ESSEX COUNTY OFFICE OF THE MANAGER

SUBJECT: Addendum #2 WATER STREET BRIDGE REPLACEMENT

This Addendum is issued to all bidders and is to be inserted into, and shall become part of the Contract Documents, including all Drawings and Specifications for the **Replacement of the Water Street (C.R. 10A) Bridge – BIN 3301700 over The Branch located in the Town of Elizabethtown, Essex County, New York** as if included therein and complete.

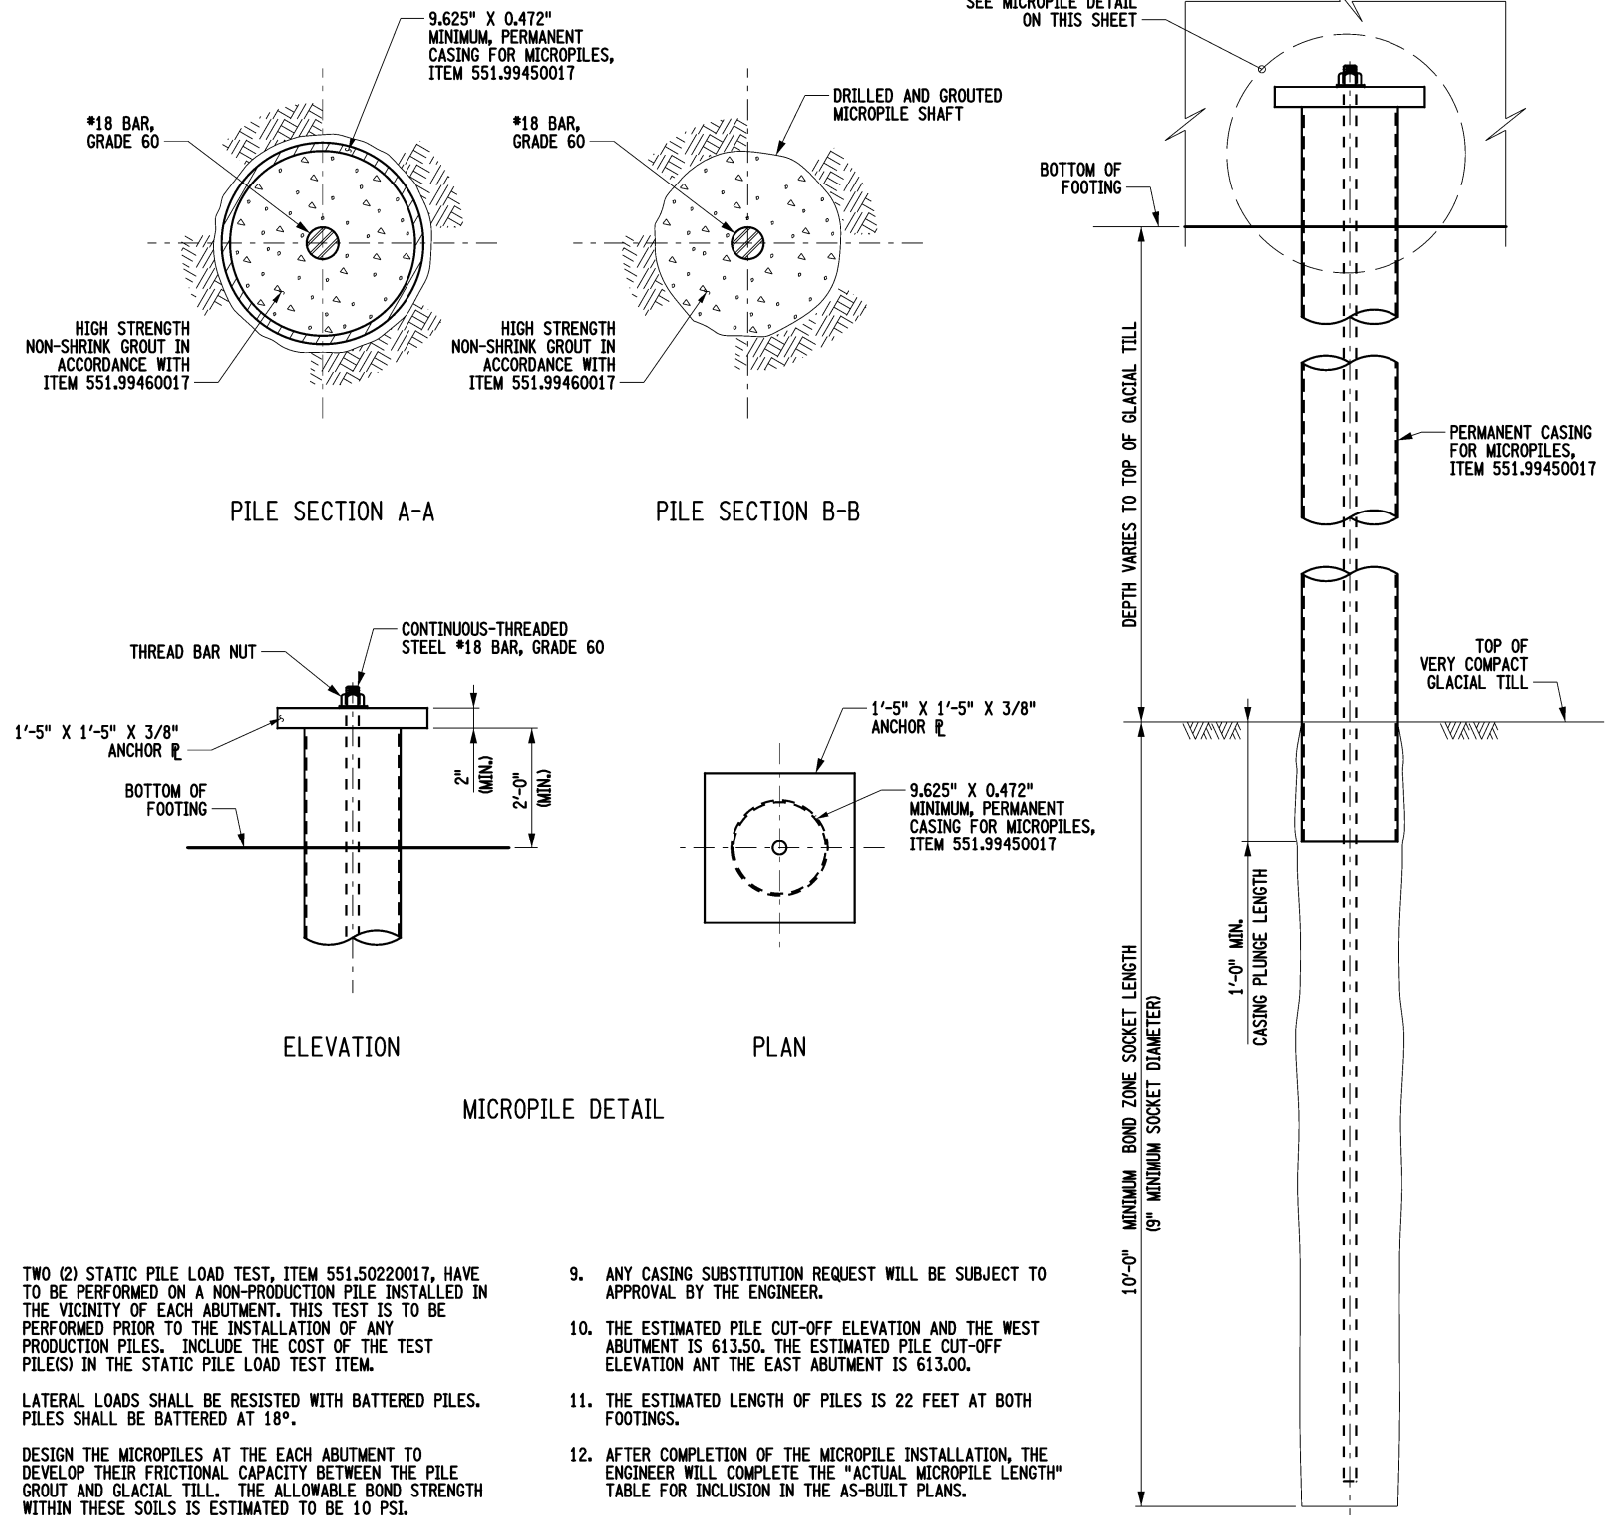
1. Added anchor plate size, minimum casing size, and grade of steel bar to the Micropile details.

· Drawing No. MP-1 (Sheet No. 9 of 61) with attached Drawing No. MP-1-R1 (Sheet No. 9 of 61)

"Please provide design loads for the Contractor Designed Micropiles."

"Please provide bearing plate dimension requirements for the micropiles."

The request has been addressed with the revision to Drawing No. MP-1 (Sheet No. 9 of 61) and the addition of Drawing No. MP-2 (Sheet No. 9A of 61).

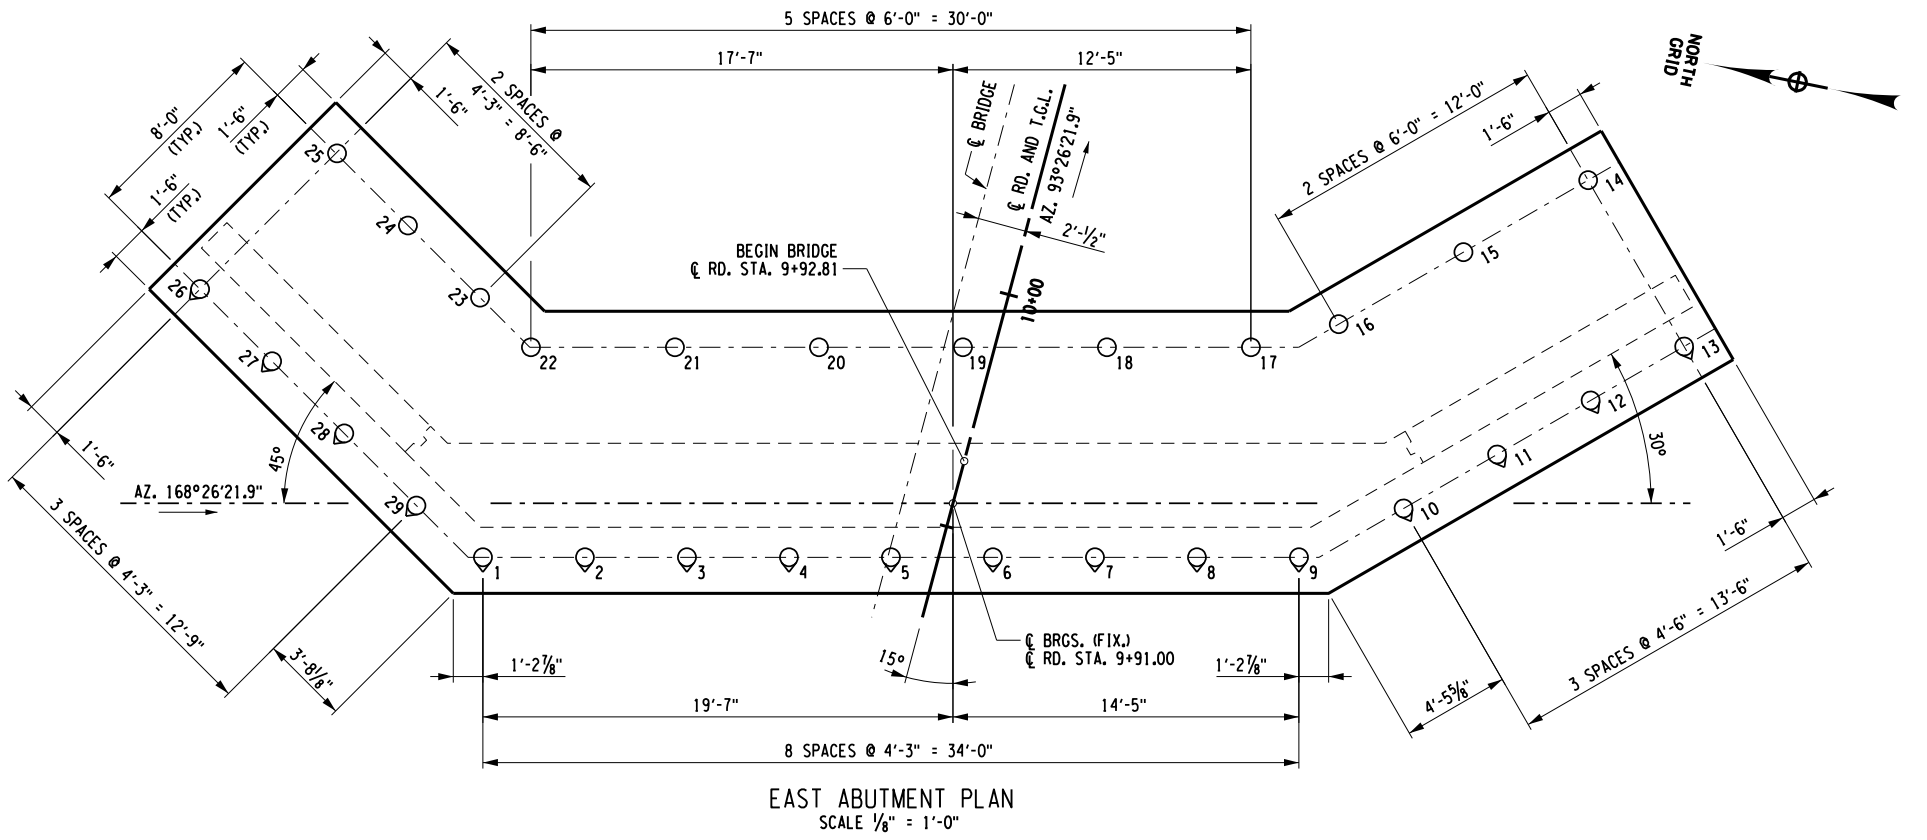
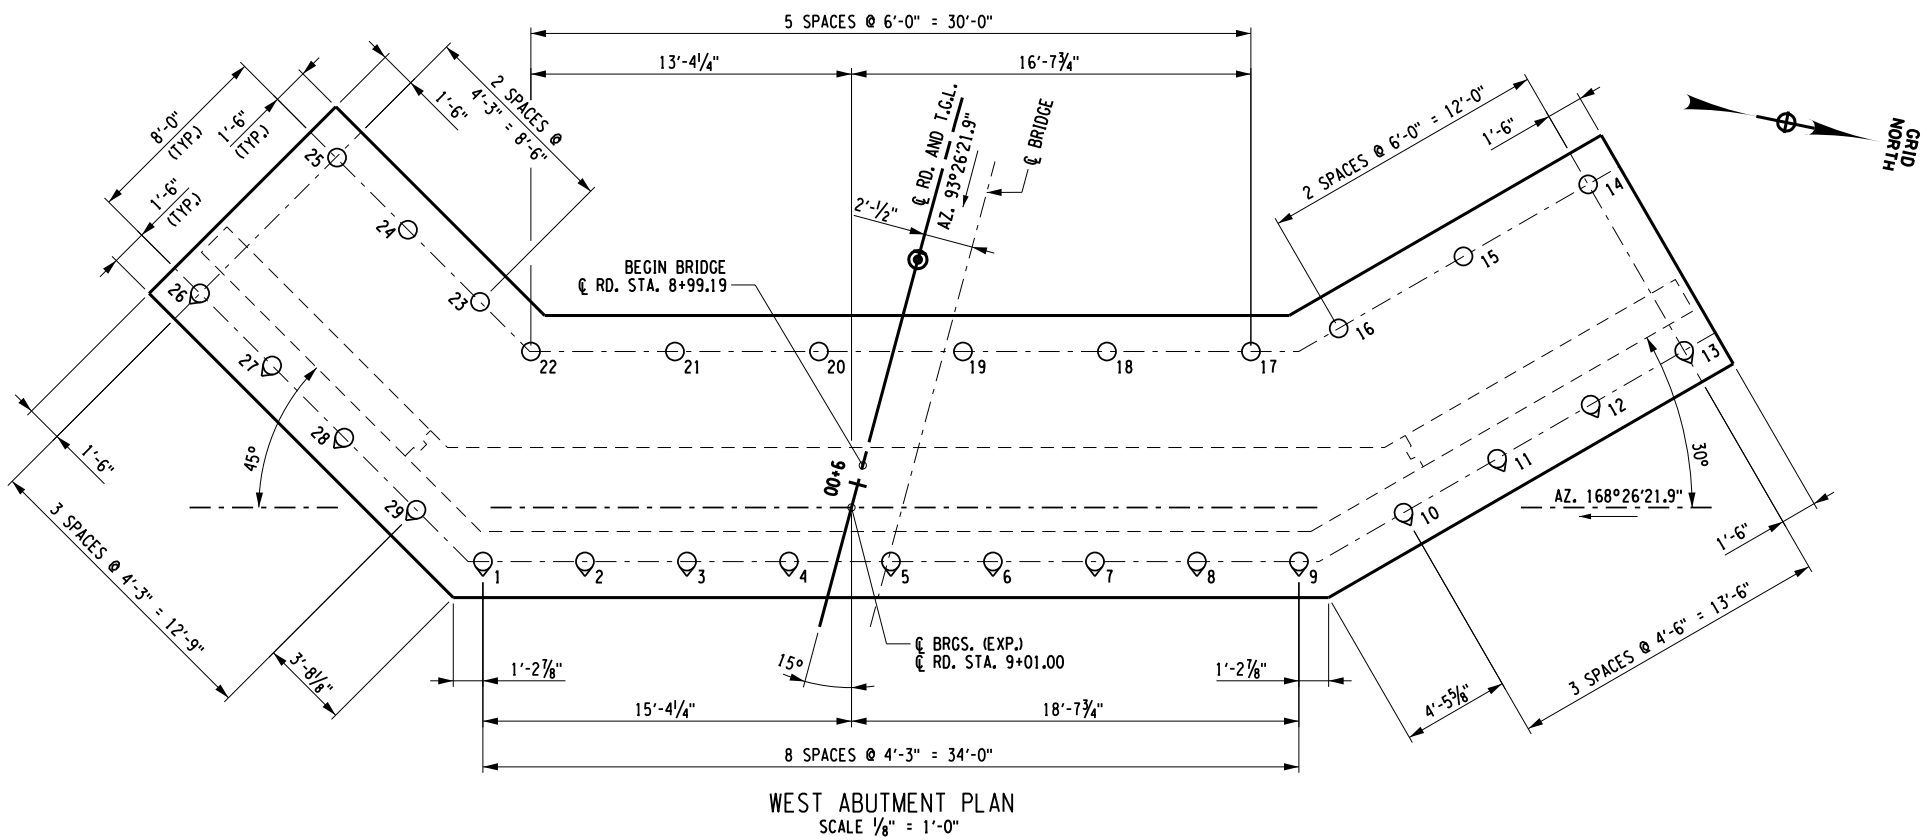
· "MICROPILE LAYOUT" - Drawing No. MP-2 (Sheet No. 9A of 61).

1) *"Please provide a micropile layout plan for the East and West Abutments."*
